Model : FAX 77/80/85/84
i-6212/6213/6215
Nashua 1040/1045
SAVINFAX 301/331
AT&T 9020FX/9022FX

RTB No. C-017

Subject: Changing the software

Subject: **Modification of cutter unit**

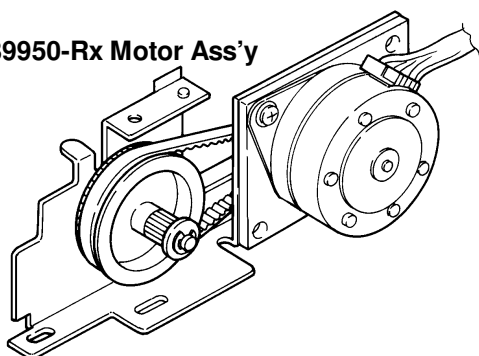
This information describes the countermeasure for the Rx motor pulley loosening on the shaft.

The stressed insertion of the shaft into the pulley during assembly in conjunction with temperature and frequent use such as c.w. turns and c.c.w. turns, causes the material of the pulley (zinc) to creep resulting in loose contact between the shaft and the pulley.

Replace the Rx motor with a modified Rx motor.

[Diagram A]

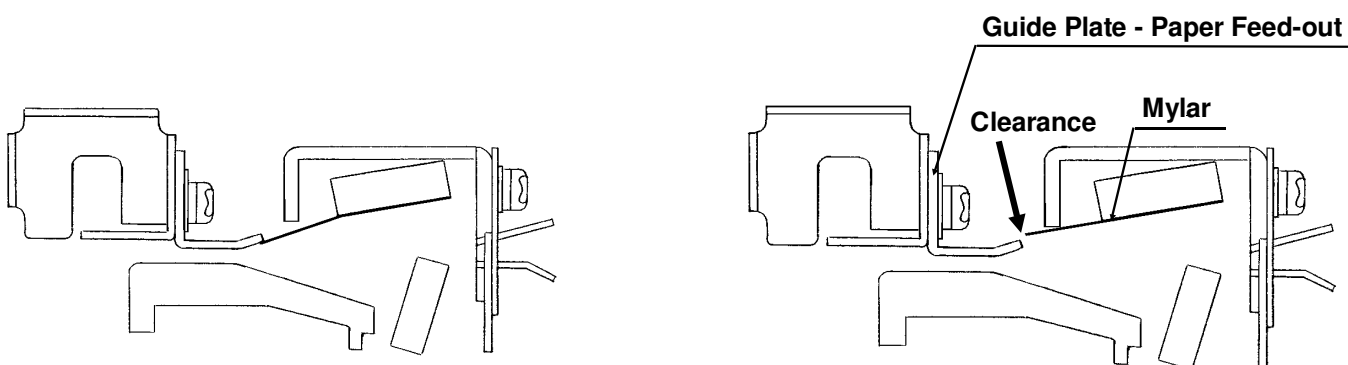
From the July, 1991 production, to prevent from paper jam at the cutter exit, a mylar has been attached to the cutter blade (Diagram A).

[Diagram B]

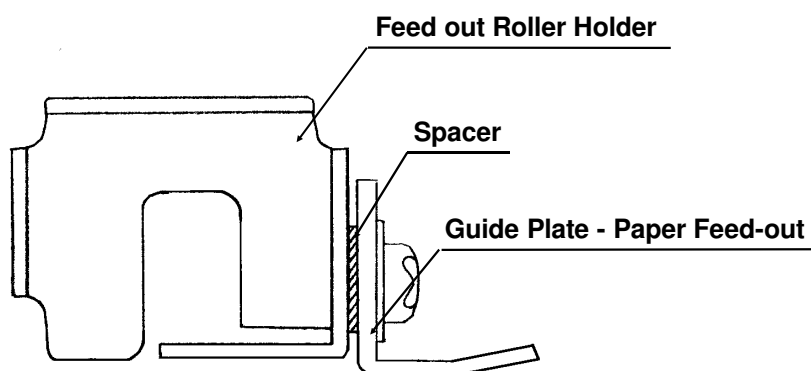
With this modification, the guide plate of the cutter exit was discontinued after the old cutter assembly was out of stock (Diagram B).

However, we found in the production line that few machines experienced paper jam due to the discontinuance of the guide plate.
